# Access Compliance Report

## Public Rights-of-Way

Intersection ID: 26636	Main Street: SAVANNAH_HILLS_DR	Cross Street: HAMPTON_GLEN_CT	Location: NE
ADA ID: 2BF9C0FE7C09	Ramp Type: PerpDiag	Initial Pass/Fail: Fail	Overall Compliance: No
		Severity Score: 12.5

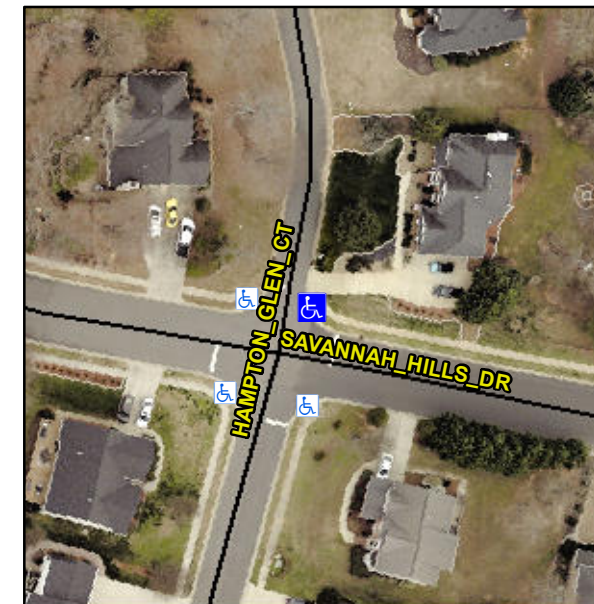
**R304.2.2**

Compliance	Description	Data	Compliance	Description	Data
N/A	Ramp Length (in)	51.0	No	Ramp Slope (%)	8.7
Yes	Ramp Width (in)	48.0	Yes	Ramp XSlope (%)	0.7
N/A	Flare Type LT	N/A	N/A	Flare Type RT	N/A
N/A	Flare Slope LT (%)	N/A	N/A	Flare Slope RT (%)	N/A
N/A	Flare Traversable LT?	N/A	N/A	Flare Traversable RT?	N/A
N/A	Landing Length (in)	N/A	N/A	DWS Provided?	N/A
N/A	Landing Width (in)	N/A	N/A	DWS Contrast?	N/A
N/A	Landing Slope (%)	N/A	N/A	DWS Length (in)	N/A
N/A	Landing X Slope (%)	N/A	N/A	DWS Full Width?	N/A
N/A	Landing Curb? (Y/N)	N/A	N/A	DWS Offset (in)	N/A
N/A	Shared Landing?	N/A			
N/A	Gutter Ponding?	N/A	N/A	Gutter Slope (%)	N/A
N/A	Gutter Lip Ht (in)	N/A	N/A	Gutter X Slope (%)	N/A
N/A	Painted X Walk1?	No	N/A	Painted X Walk2?	No
	X Walk 1 Direction	To W		X Walk 2 Direction	To S
N/A	X Walk 1 Width (in)	N/A	N/A	X Walk 2 Width (in)	N/A
	X Walk 1 Slope (%)	2.7		X Walk 2 Slope (%)	2.2
	X Walk 1 X Slope (%)	0.5		X Walk 2 X Slope (%)	0.5

**Remove & Replace Curb Ramp With Two New Directional Ramps or Equivalent.**
